RE: **Lot 6 Block 4 Unit 18, S.A.D. 228**
Volcano Cliffs Subdivision
6600 Papagayo Rd NW
Grading and Drainage Plan
Engineers Stamp Date 1/2/18 (D10D003J6)

Based upon the information provided in your submittal received 1/03/18, this plan is approved for Grading Permit.

PECK (BUILDER: MICHAEL SANCHEZ) — GRADING & DRAINAGE PLAN

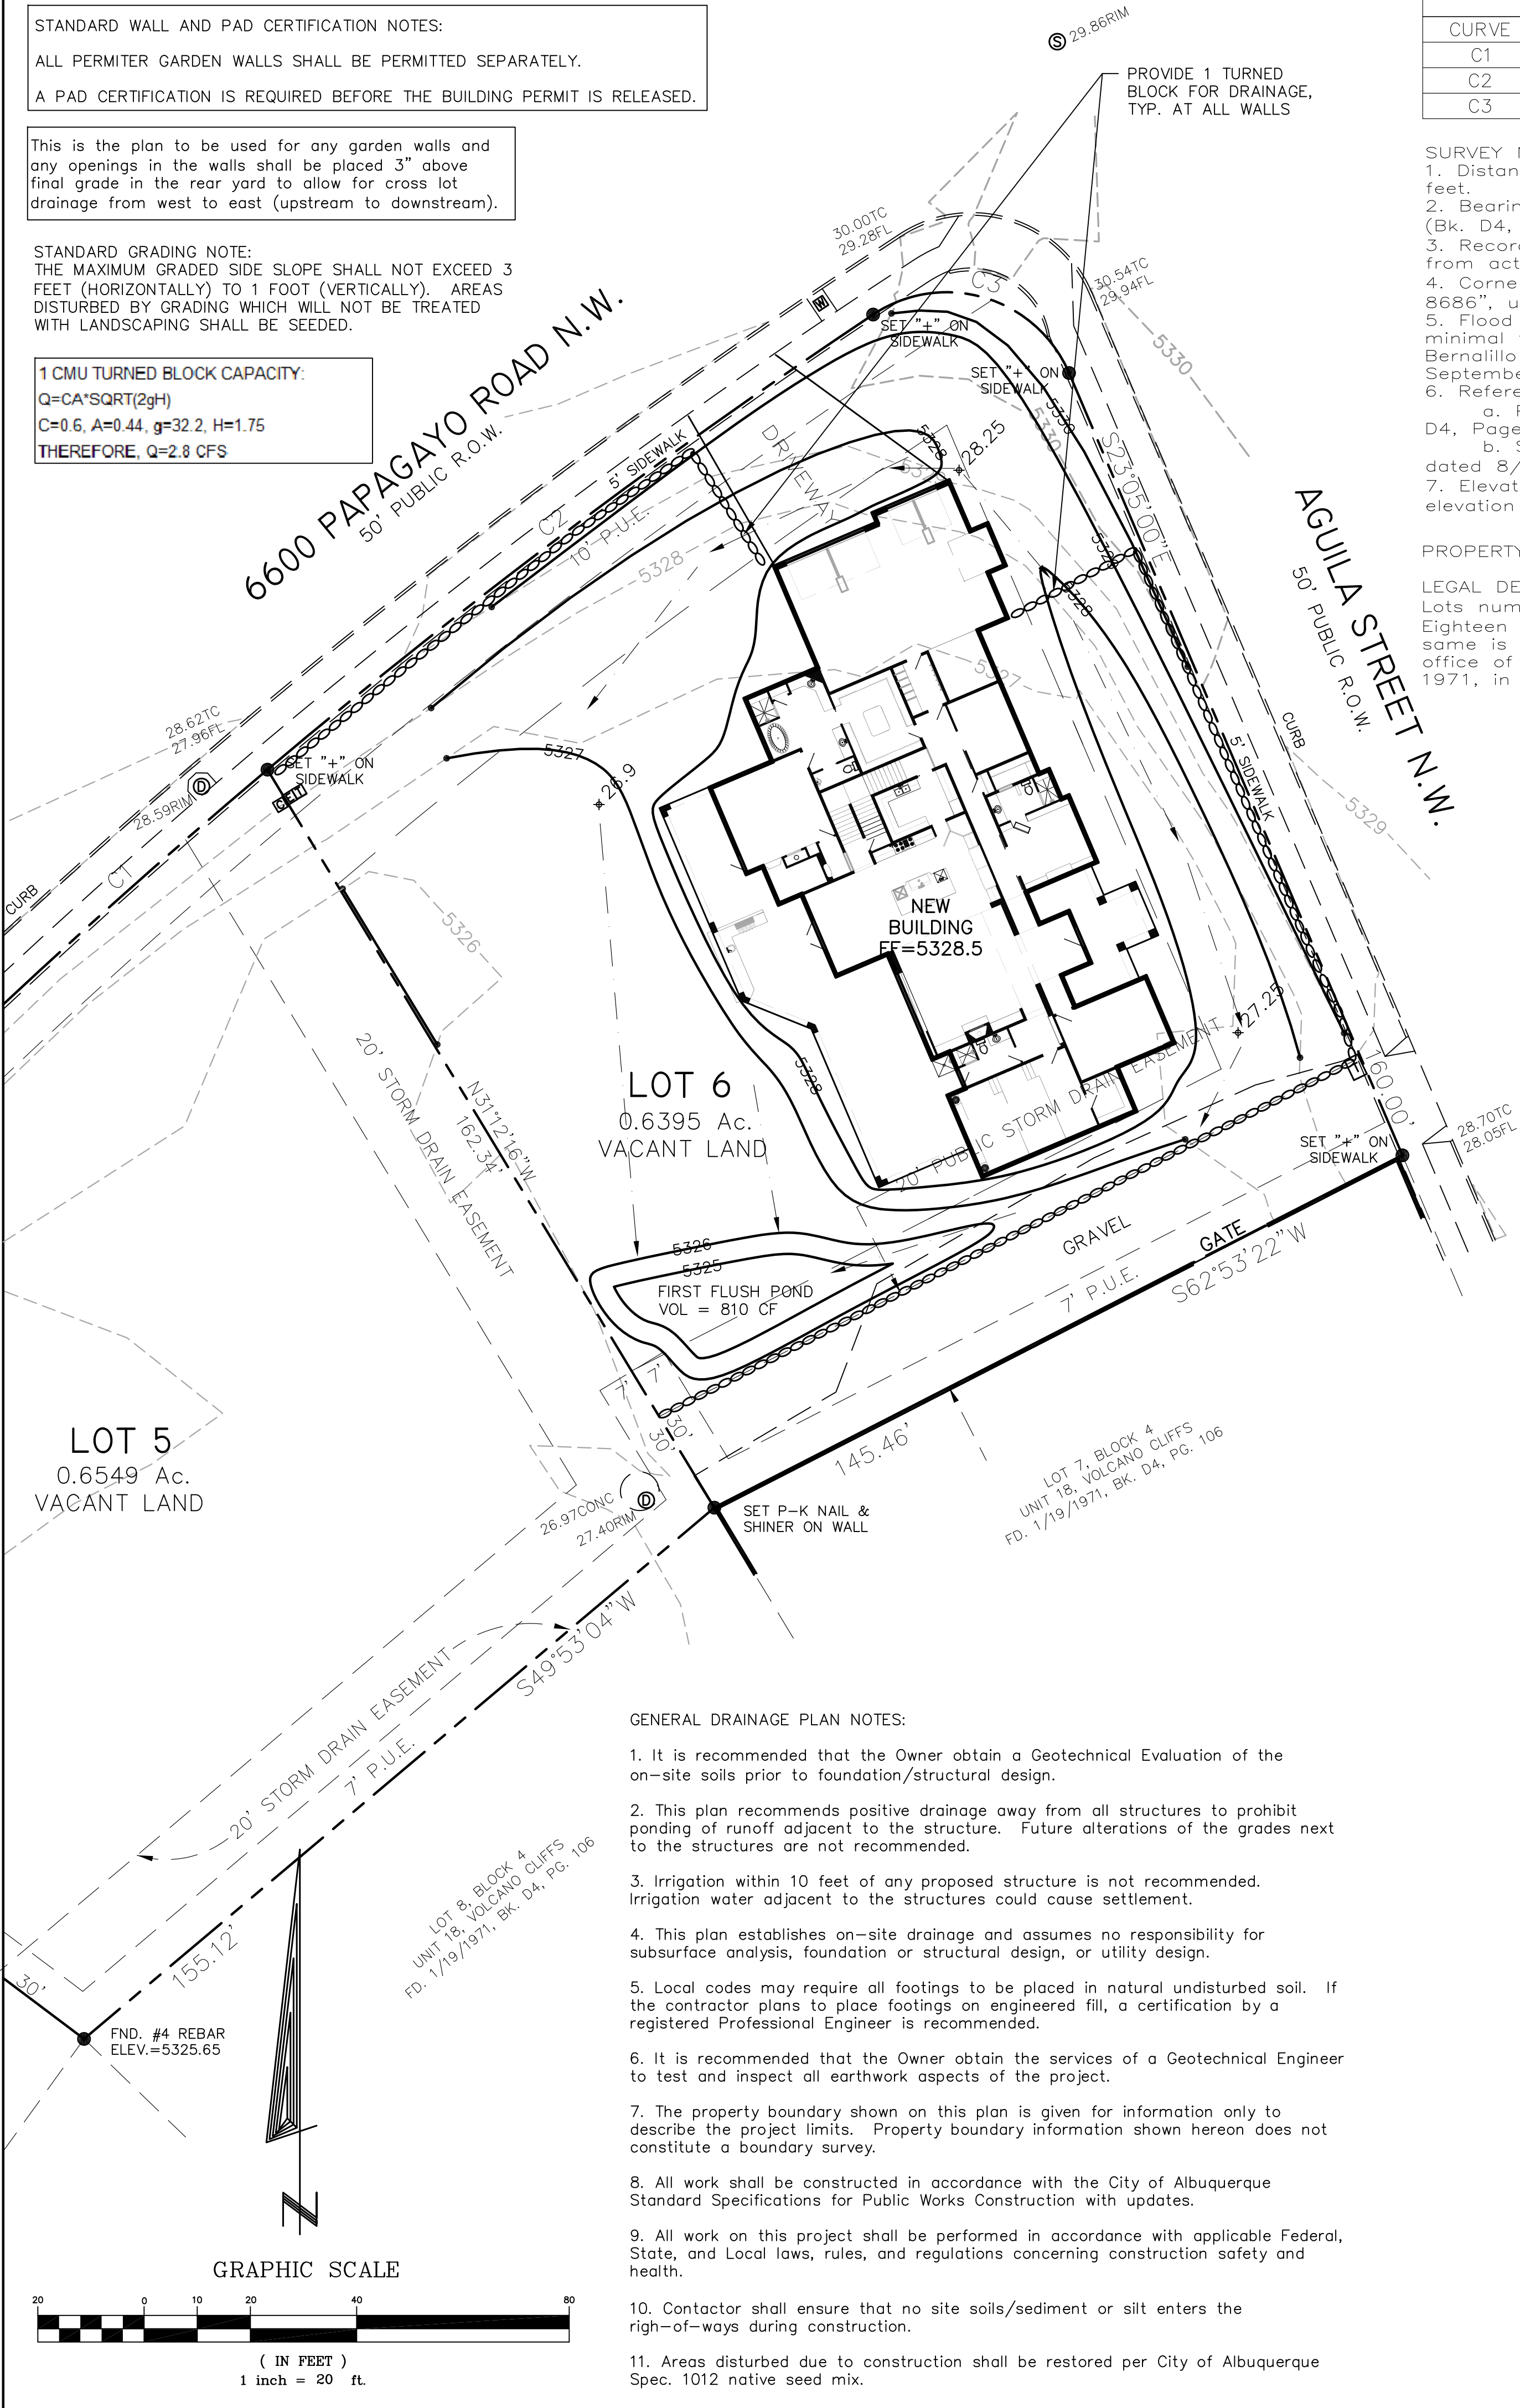
Prior to Building permit approval a Pad Certification will be required, provided by the Engineer or a registered Land Surveyor.

Reiterate to the Owner/Contractor that a separate permit for a garden/retaining wall must be obtained, with the approved G&D plan dated 1/2/18.

Prior to Certificate of Occupancy release, Engineer Certification per the DPM checklist of this plan will be required.
